**SUBJECT: THREE MILE ISLAND, UNIT 1 (TMI UNIT 1)
OPERATING LICENSE No. DPR-50
DOCKET No. 50-289
LICENSE AMENDMENT REQUEST No. 311 – REACTOR COOLANT
SYSTEM PRESSURE-TEMPERATURE SAFETY LIMITS**

TMI Unit 1 License Amendment Request No. 311

Safety Evaluation and No Significant Hazards Consideration

Figure 1

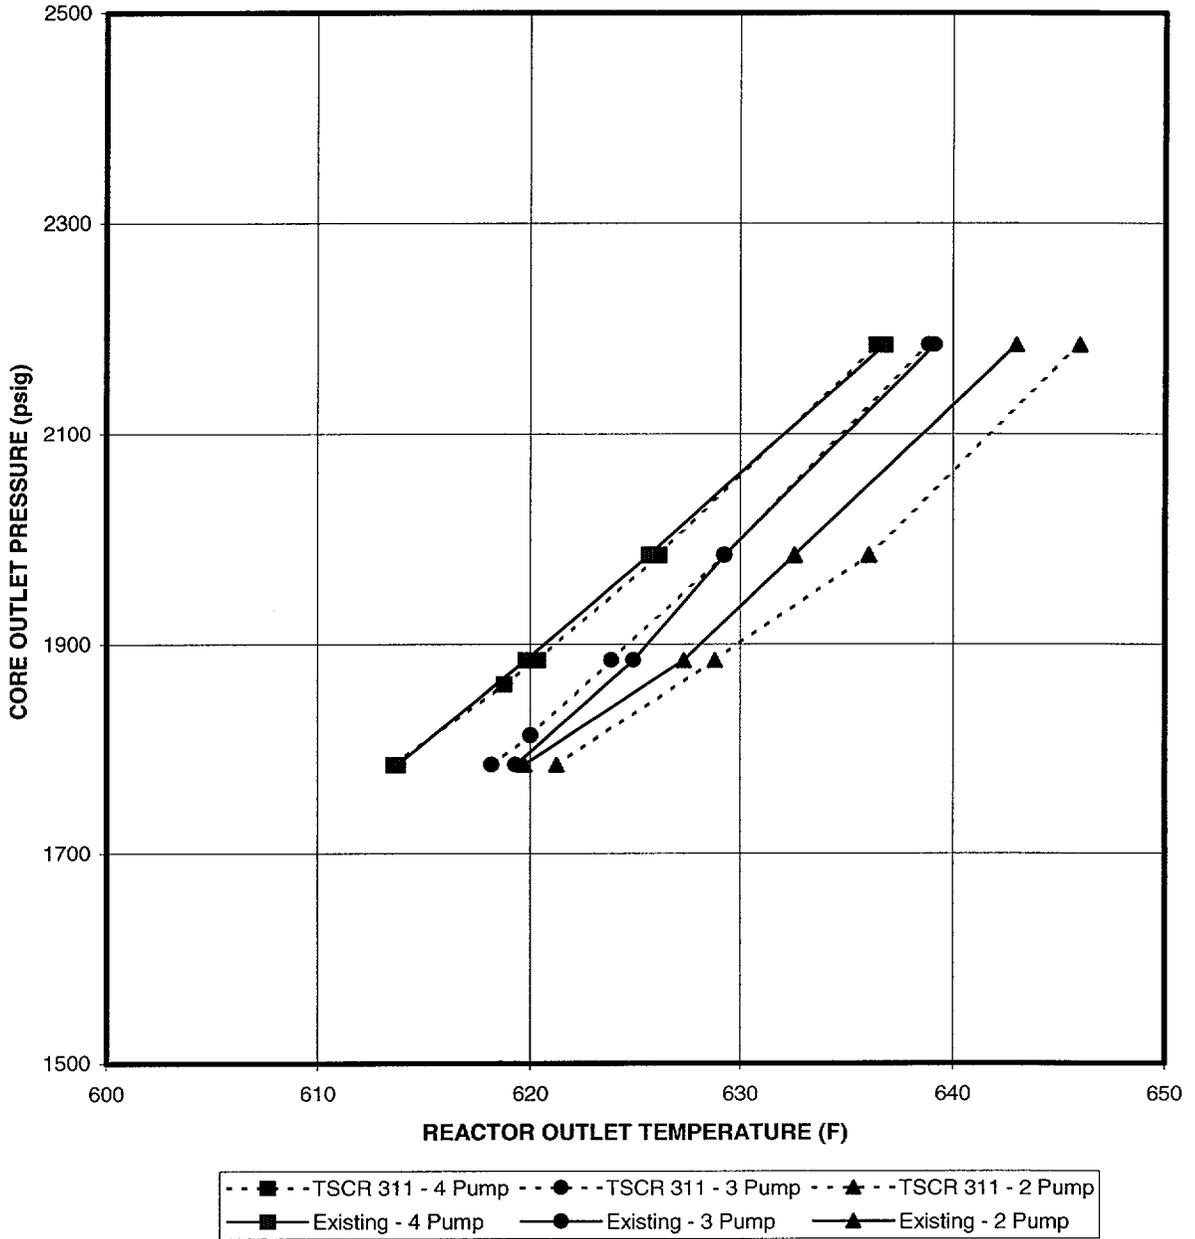
Figure 1 shows a comparison of the existing variable low RCS pressure-temperature protective limits to the proposed limits that were developed in accordance with the methods described in the NRC-approved Topical Report BAW-10179 P-A. Both sets of limits in Figure 1 were developed assuming a minimum reactor coolant system design flow rate of 102% flow. For comparison purposes, Figure 1 reflects the proposed change in Technical Specification Figures 2.1-1 and 2.1-3 pressure coordinates to core outlet pressure in lieu of hot leg pressure tap values described above. The use of core outlet pressure is consistent with the BAW-10179 P-A analysis methods. This comparison shows that the most limiting 4-pump limits, as well as the 3-pump limits, are similar to the existing Technical Specification limits and bases. The differences for the 2 pump condition are due to additional conservatism inherent in the existing limits which were conservatively developed assuming a maximum core quality limit of 20% while the proposed limits are based on a maximum core quality limit of 26%, which is the NRC-approved local quality limit for the BWC CHF correlation. The revised limits are incorporated in the proposed Technical Specification Figures 2.1-1 and 2.1-3.

CORE PROTECTION SAFETY LIMIT
TMI-1
FIGURE 2.1-1

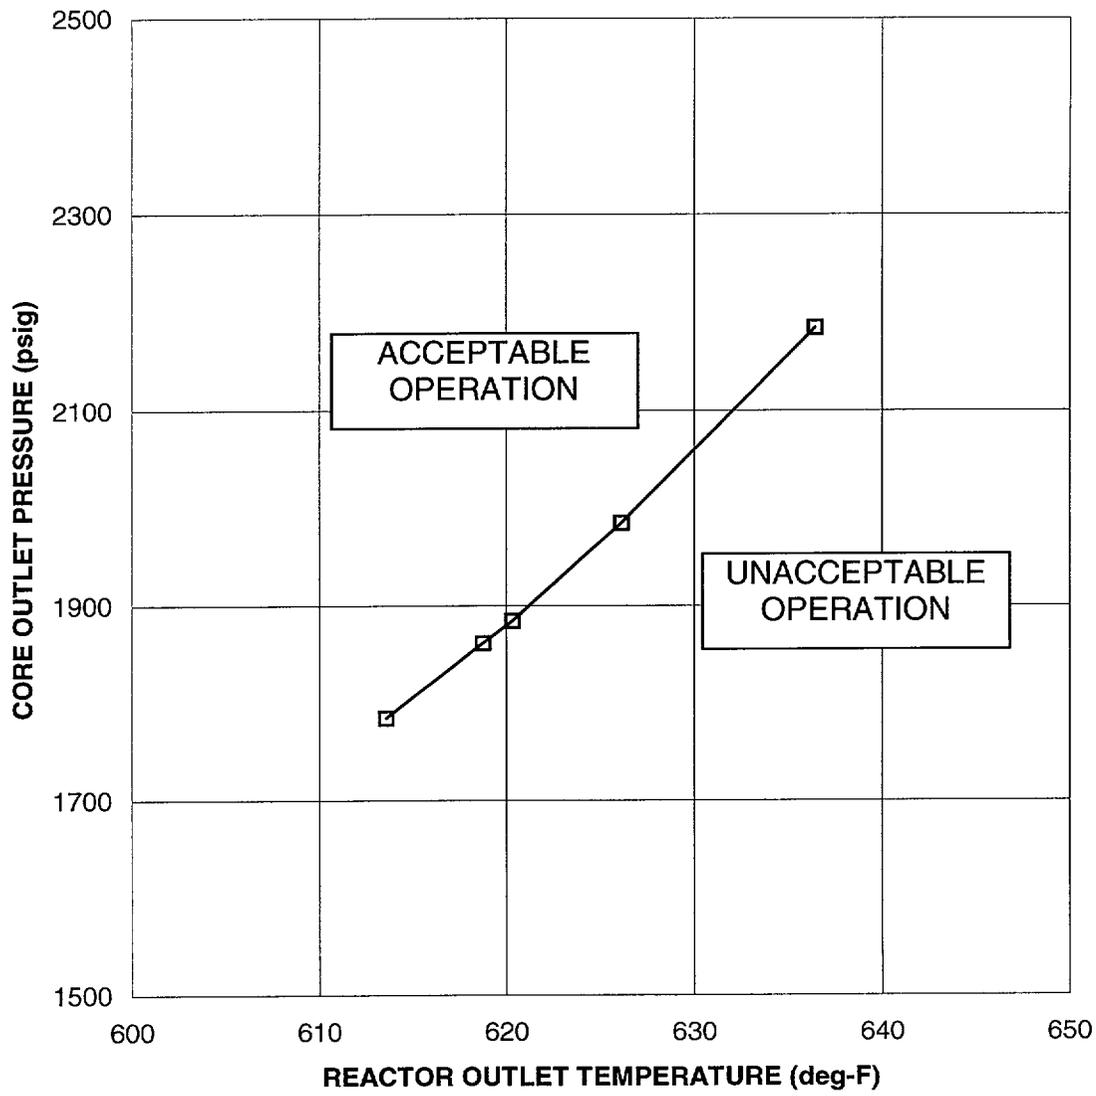
The proposed change revises the variable low reactor coolant system (RCS) pressure-temperature core protection safety limits contained in Technical Specification Figure 2.1-1 and associated Technical Specification Section 2.1 Bases and Bases Figure 2.1-3.

of the NRC-approved methods previously utilized for Cycles 12 & 13 results in the change to the core outlet pressure coordinates specified on Figures 2.1-1 and 2.1-3. The pressure coordinates are revised to reflect actual core outlet values in lieu of hot leg tap values. The use of a maximum core quality limit of 26% as specified by BAW-10179 P-A for the BWC CHF correlation revises the 2-pump and 3-pump limits specified on Technical Specification Figure 2.1-3.

The proposed Technical Specification limits (Figure 2.1-1) are developed in accordance with the methods and assumptions described in NRC-approved Framatome ANP Topical Report BAW-10179 P-A, "Safety Criteria and Methodology for Acceptable Cycle Reload Analyses." These limits remain bounded by the existing reactor protection system (RPS) trip setpoints. The TMI Unit 1 Cycle 14 core introduces the Framatome ANP Mark-B12 fuel design. The Mark-B12 fuel design is mechanically and hydraulically similar to the fuel designs currently in use at TMI Unit 1. While the designs are hydraulically similar, the Mark-B12 contains a fine mesh debris filter that alters the flow characteristics at the core inlet relative to the resident fuel designs resulting in the identification of a transition core DNB penalty. The higher minimum RCS flow requirement (105.5%) applied to offset the transition core DNB penalty is bounded by the minimum RCS flow assumed in current Updated Final Safety Analysis Report (UFSAR) Chapter 14 accident analyses (102%).

FIGURE 2.1-3

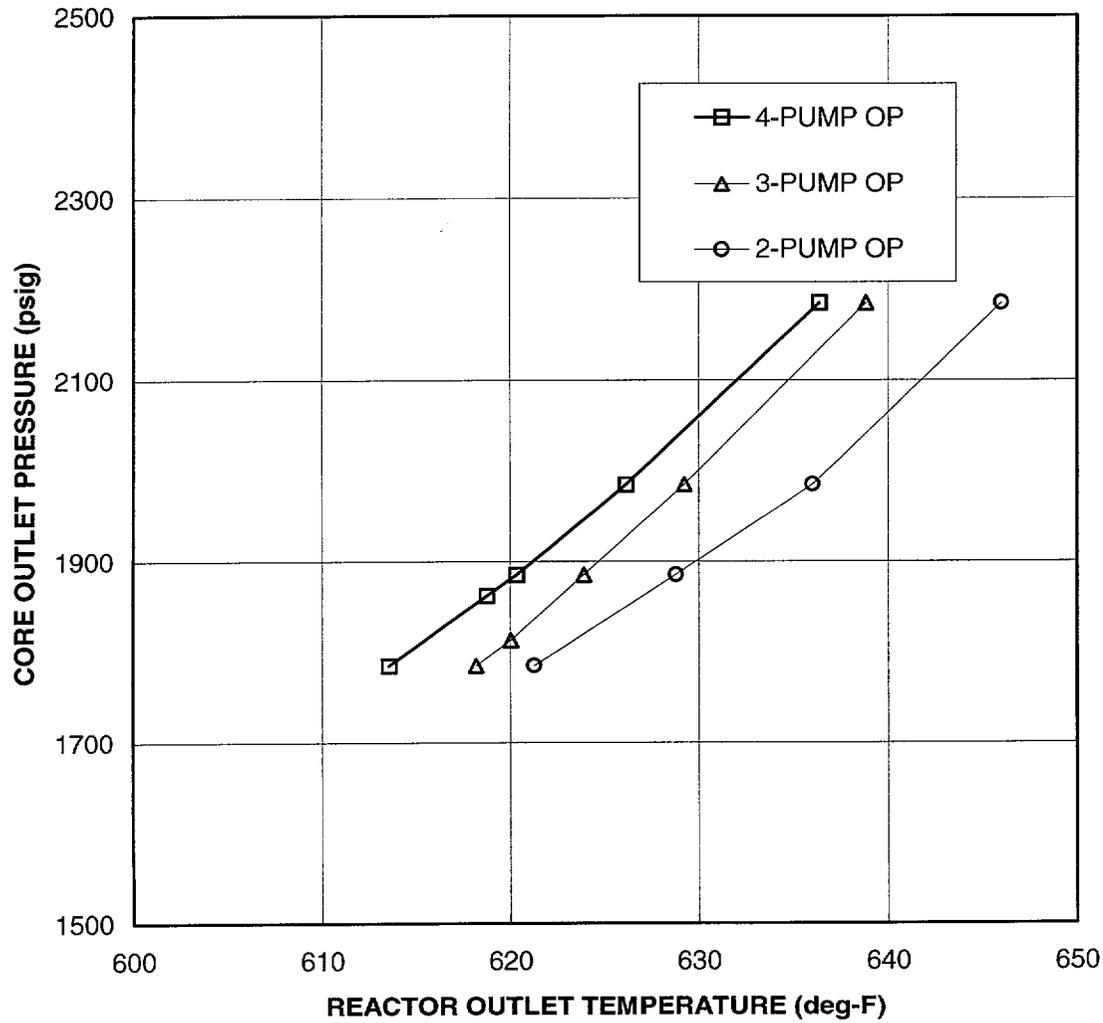
These changes are required as a result of the TMI Unit 1 Cycle 14 core reload design analyses performed in accordance with approved Framatome ANP methods as described in NRC-approved Topical Report BAW-10179 P-A, "Safety Criteria and Methodology for Acceptable Cycle Reload Analyses," as listed in existing TMI Unit 1 Technical Specification Section 6.9.5. An additional change to the minimum RCS flow requirement for 4-pump operation to offset the Cycle 14 transition core DNB penalty is also incorporated in the Core Protection Safety Bases Figure 2.1-3.

The curves of Figures 2.1-1 and 2.1-3 were developed assuming a reactor coolant design flow rate of 102% of 352,000 gpm. However, a higher minimum flow rate (105.5% of 352,000 gpm) is specified in order to offset transition core effects due to the introduction of the Mark-B12 fuel design with fine mesh debris filter.
